**CITY OF BOULDER**  
**PLANNING BOARD MEETING AGENDA**  
**DATE:** September 1, 2016  
**TIME:** 5 p.m.  
**PLACE:** 1777 Broadway, Council Chambers

- A. AGENDA TITLE:** Public hearing and consideration of a Site and Use Review (LUR2016-00056 & LUR2016-00057) proposal to establish a retail store and café use at 1815 Pearl St. The total square footage of the tenant space is 2, 642 square feet with 1,984 square feet of retail and 658 square feet of café space with 40 seats. A concurrent site review has been submitted for consideration of an 89% parking reduction.

- D. AGENDA TITLE:** CONCEPT PLAN & REVIEW - Concept Plan Review and Comment for redevelopment of 1102 Pearl Street (currently the Old Chicago Restaurant) into a 15,380 square foot, three story retail office building of 38 feet. Reviewed under case no. LUR2016-00058.

**CITY OF BOULDER  
PLANNING BOARD AGENDA ITEM**

A: Proposed Plans

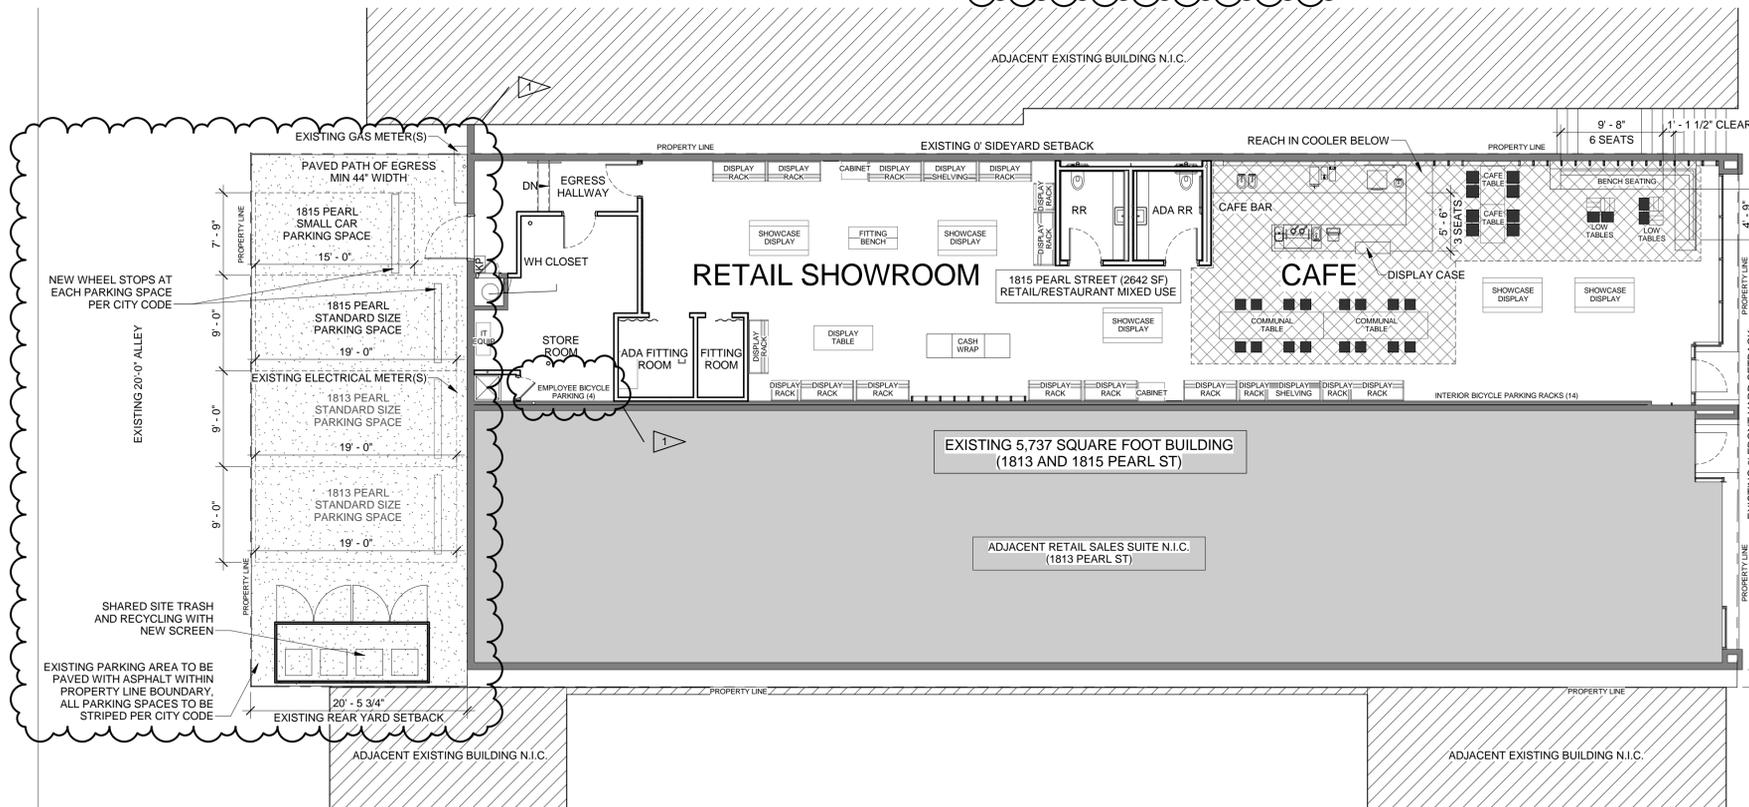
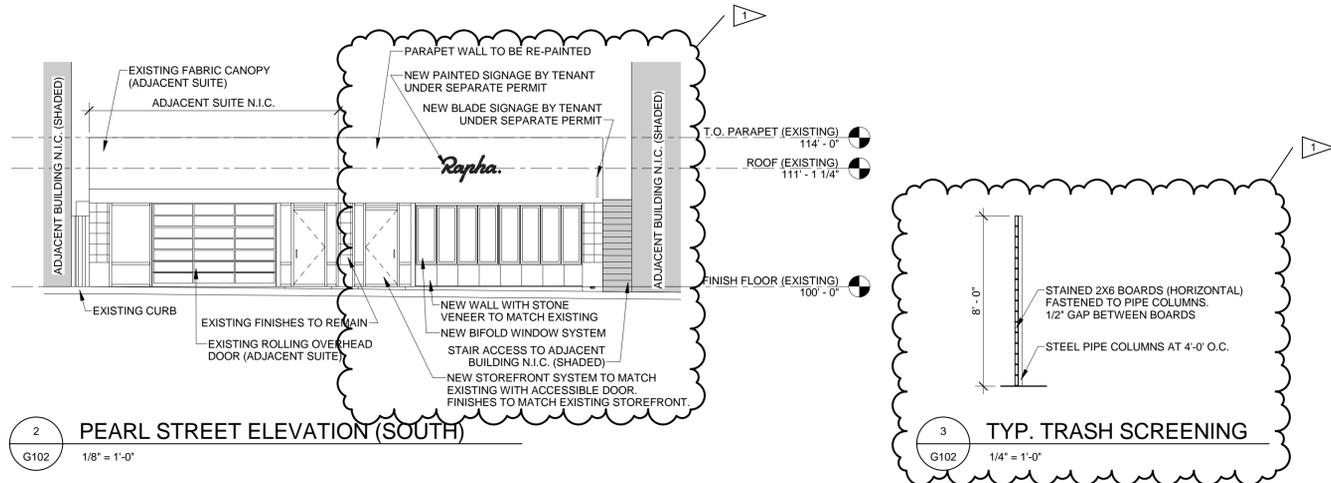
1. Label the trash and recycling locations and how they are being screened to meet the minimum requirements (full screening) of section 9-9-12(d)(5) B.R.C. 1981.
2. This stretch of Pearl Street has no existing public street trees. Additional information on existing conditions must be added to the site plan including, but not limited to, location of the water meter, parking kiosk, existing tree to the west and any other dry utilities. It appears that one additional street tree fits into the existing conditions approximately 23 feet on center from the existing tree to the west. The tree shall be in a 4x12 grate consistent with similar planting conditions elsewhere on Pearl. Installation by forestry?

Figure 11b (proposed concept)

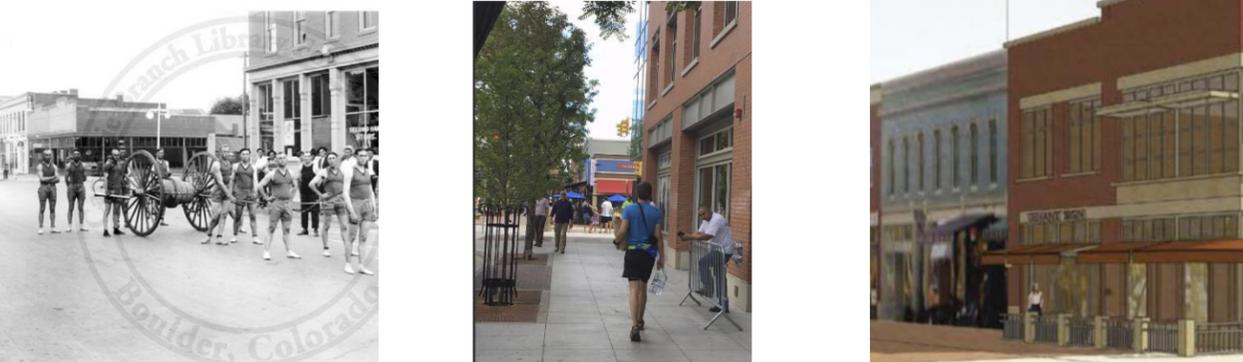
- Consider alternative means to accentuate the corner rather than the tall parapet. One consideration is to move the three story building mass to the corner and be honest about the third story in this prominent intersection location. While the code standard is a 15-foot setback, corners can hold the height within the downtown. The example precedents (while much taller) are the new PearlWest across 11<sup>th</sup> Street as well as the corners of Broadway and Pearl. In this location three stories would be compatible in the context to punctuate the terminus of the Pearl Street Mall, and at the corner rather than setback. This is a consideration that must take careful thought and discussion with staff. Refer to [Attachment A](#) and a preliminary consistency analysis with the design guidelines.

- The tall parapet at the corner does not appear proportional to the rest of the building and creates an appearance of a very tall second story.
- The retractable doors on the ground floor aren't historically consistent in this context and wouldn't meet guideline 1.3.A (refer to the discussion in the following matrix).

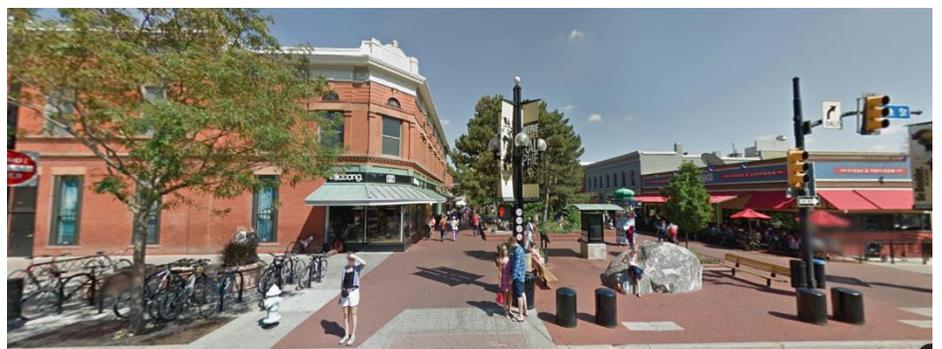
1. At time of Site Review the following elements of the plans must be addressed:
  - Show the required 15' x 15' sight triangle as shown in figure 9-7 of the Boulder Revised Code, 1981 (B.R.C.) where the alley intersects 11<sup>th</sup> Street adjacent to the site.
  - Provide a narrative on where the off-street deliveries/loading space will be and how it's expected to operate for both the restaurant and commercial uses. Staff concurrence is required if the applicant proposes to use the existing alley to meet the site's off-street loading standards pursuant to section 9-9-9 of the B.R.C. 1981. Currently only the east end of the alley is signed for deliveries / loading in this block. Also, the location of the delivery / loading space can't block or obstruct any public street, parking area, parking area circulation, sidewalk or pedestrian circulation area.

- Show the location for the trash storage and recycling areas to be provided on the site pursuant to section 9-9-18 of the B.R.C. 1981.
2. Should off-street parking be provided, please show the off-street parking meeting the design standards for parking pursuant to Section 9-9-6 of the B.R.C. 1981 to include providing the required standard parking spaces, labeling the dimensions of the parking spaces and providing the required 24-feet for the backing distance exclusive of the width allocated in the alley for the dumpsters.
